RE: Calico Solar (formerly Solar One) Project (08-AFC-13)
Bureau of Land Management Record of Decision – Compiled Appendices

Appendix 1
Response to Comments on the Final
Environmental Impact Statement

Photograph of SunCatcher Solar Dish Array

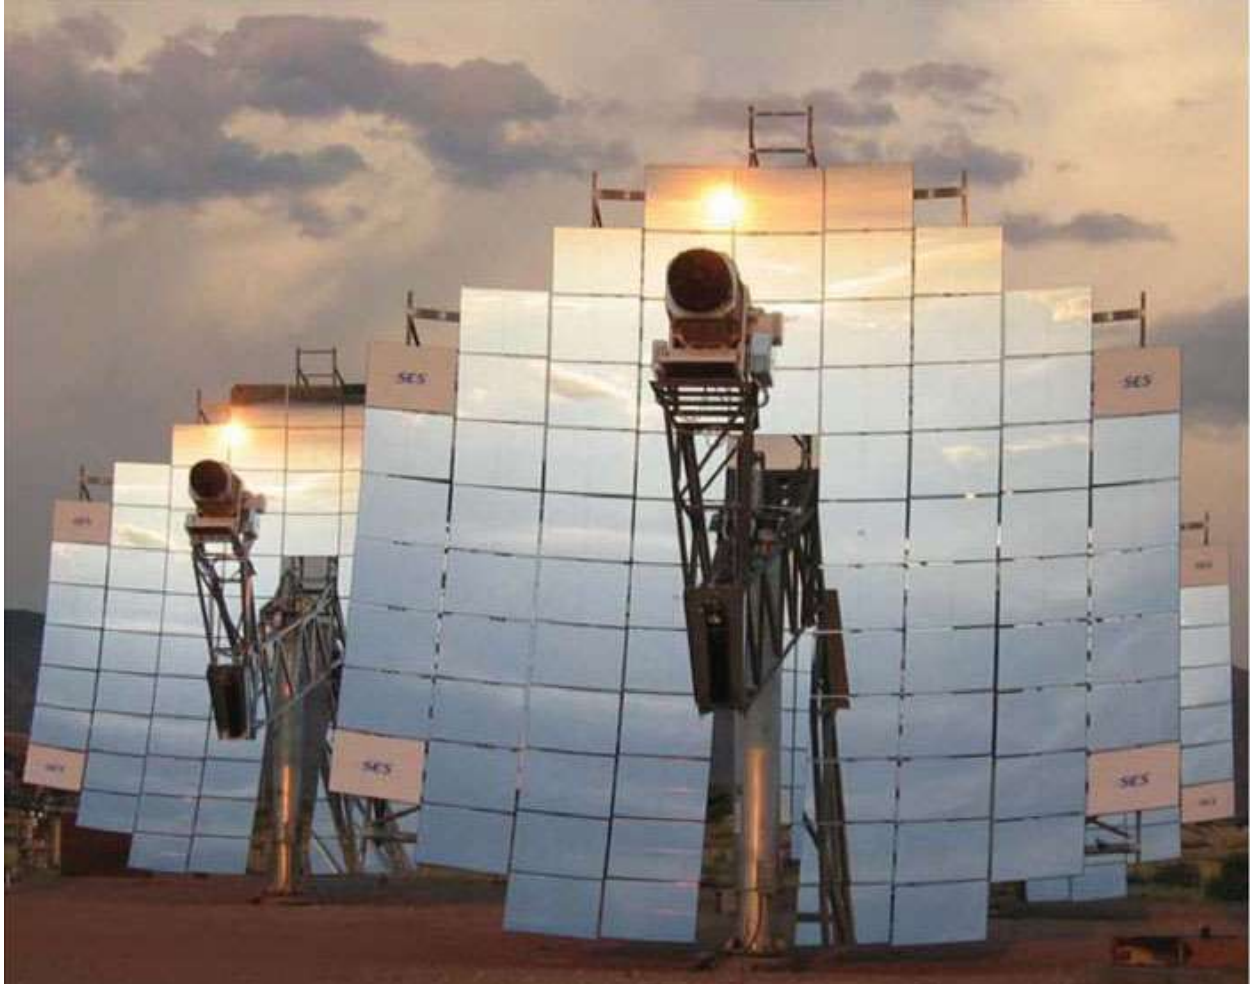
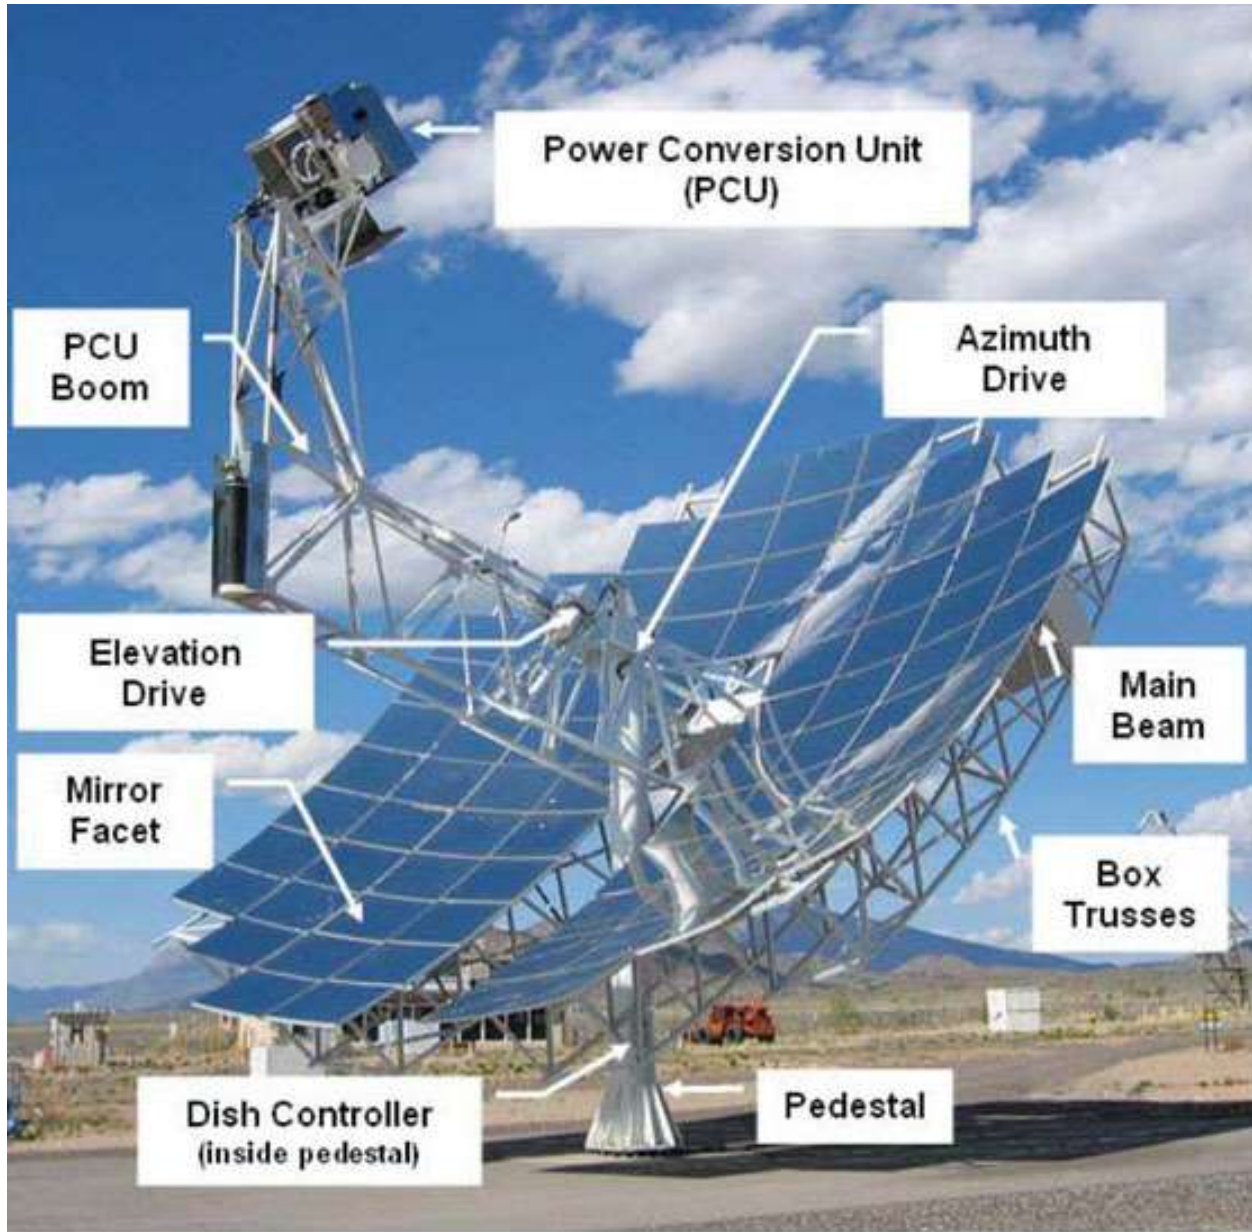
Comment Calico-4: [T]he FEIS provides photographs of SunCatcher dishes. The photographs depict an older model of the dish; photographs of the current generation of SunCatcher dish are provided in the Plan of Development at page 14 (Figure 8). (p. 3)

Response: Subsequent to publication of the FEIS, additional information regarding the Calico Solar Project has been provided to and docketed by the CEC, and CEC staff has published a Supplemental Staff Assessment acknowledging that information. BLM can likewise acknowledge new information received after publication of the FEIS in development of the ROD. BLM has considered new information and changes in circumstance in light of the information and analysis of the FEIS, pursuant to the provisions of Section 5.1 of the BLM NEPA Handbook H-1790-1.

Requests to change the text of the FEIS and address typographical errata are noted.
